Procedure: 001	Rev: 6.0
Title: Gortyrhilly Telecommunications Impact Study	Approved: KH	Date: 21/07/22

Gortyrhilly Wind Farm Telecommunications Impact Study

Ai Bridges was commissioned to evaluate the possible impacts that the proposed wind farm development at Gortyrhilly, Co. Cork could have on a number of telecom networks which have been identified as possibly being impacted by the proposed development.

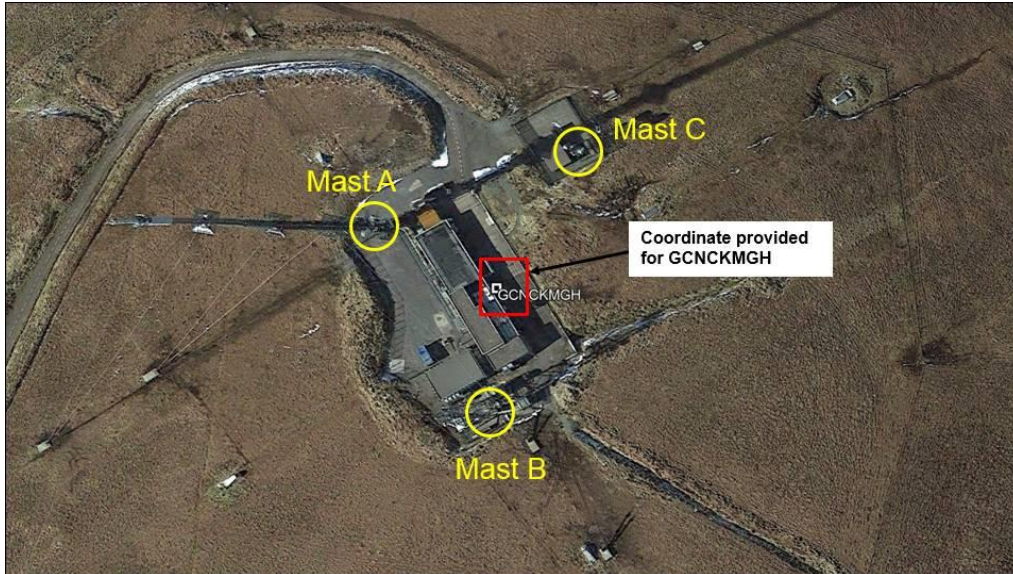
e.g. The coordinates listed for B-End “GCNCKMGH” (Mullaghanish) are 51.98321, -9.1437, but these coordinates appear to be centred on the entrance to the main site-building and not on a Telecoms Mast (See screengrab below).

We would appreciate it if you could confirm if the radio antenna is actually installed on the New 2RN Mast (Mast A), the Old 2RN Mast (Mast B) or the ESB Telecoms Mast (Mast C). We have added a column to the Table with our comments.

That's a centre point co-ordinate by the looks of it. Possibly because the radio panels are spread out through the site and we use the radio co-ordinates, I'm not sure? But the dishes are on the tower at: 51.983378, -9.144229, all at varying heights.

Vodafone Network - Plan View

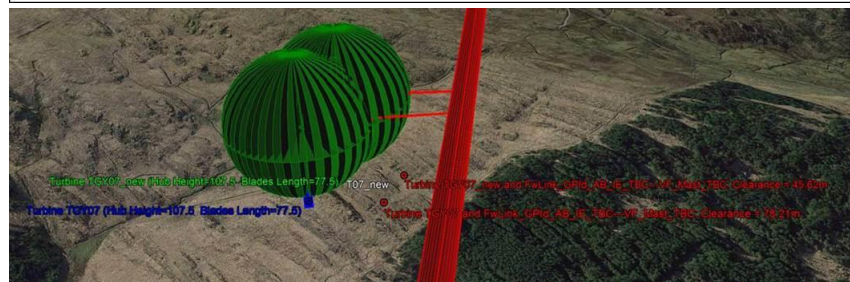
Our client has reverted to us earlier today and it appears that there is a land boundary issues i.e. another constraint that requires the T07 wind turbine to be micro-sited. This has caused the planning application from being submitted. We have advised our client that Vodafone specifically requested to be notified of any changes thus we are raising this as a possible concern for Vodafone.

We have conducted our analysis based on the new turbine co-ordinates and we are seeing that the clearance from the Inchee-Cashelmore link has been reduced from 78.21m to 45.26m. The revised co-ordinates that we have received for T07 are

We would be grateful if you could review and confirm that this clearance would be acceptable i.e. outside the 30m buffer from the 1st Fresnel by 15m

Thank you for the update. This new position should be fine, with usual caveats including assumption that all co-ordinates are accurate.

*Happy that the new position should not interfere.
If you need anything else, please let me know*

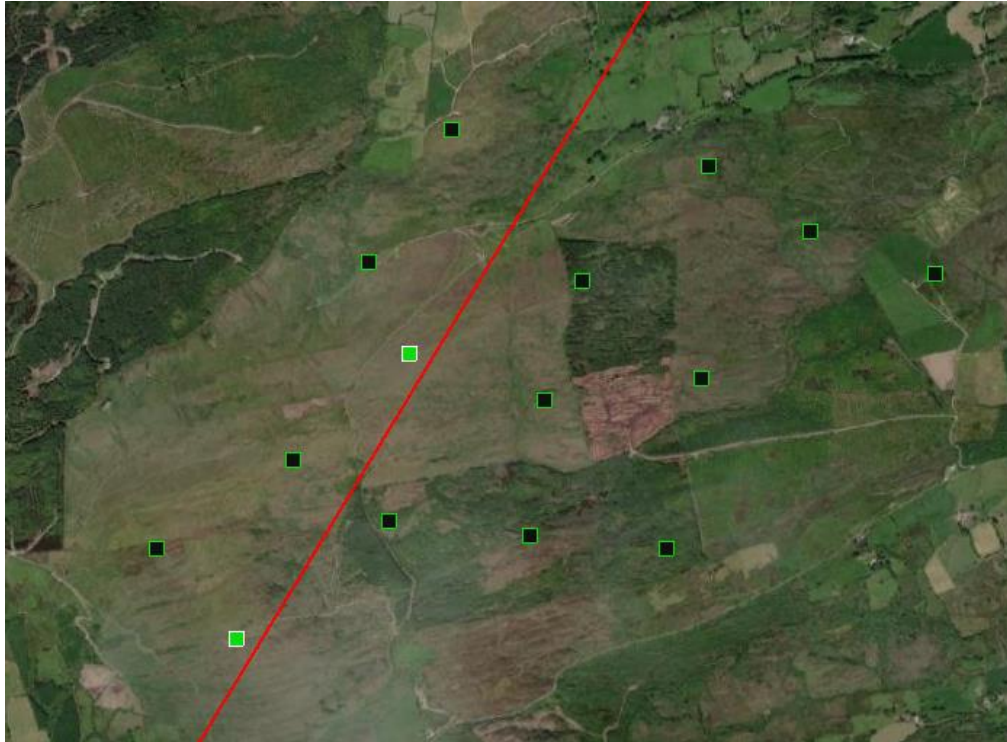
*Turbines 1 and 8 from the latest list you sent – the two highlighted in green below.
Regarding the UHF links – yes, we think there is a low enough risk of interference to these links with the latest turbine locations.*

Turbine Clearance Calculations

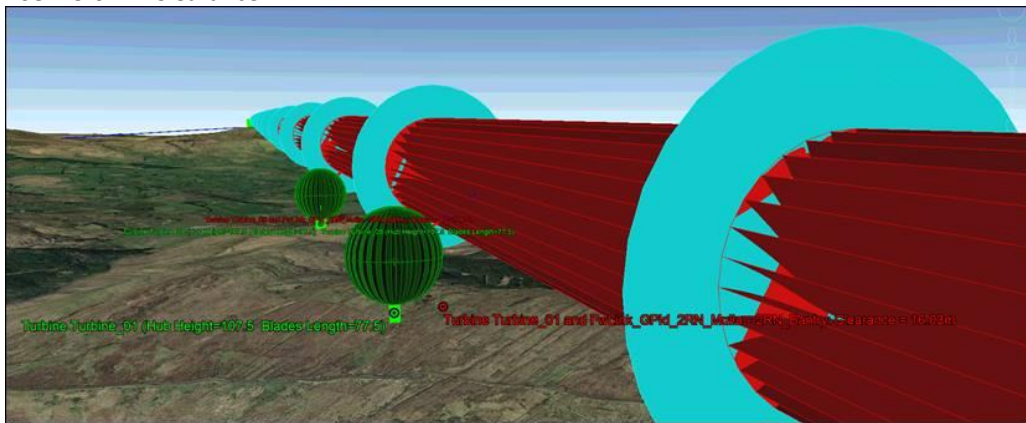
Using the AiBridges Calculations for 0.6 F1 there is a Clearance Condition to each of the turbines (T01 & T08 as shown below)

- T01: 16.03 m Clearance
- T08: 15.67 m Clearance

Hi Kevin, David, thanks for looking into this – the formula is certainly correct, and is how I would do it by hand. I don't know how Radiofesnel.com does it, but I think we may be seeing a difference

You’ll see it done both ways. I can’t honestly say which is “correct” – only that this is really more of a rule of thumb as I understand it, so I think we should be erring on the side of caution given that we should really be looking at 1st of 2nd zone clearance for fairly reflective surfaces like turbine blades.
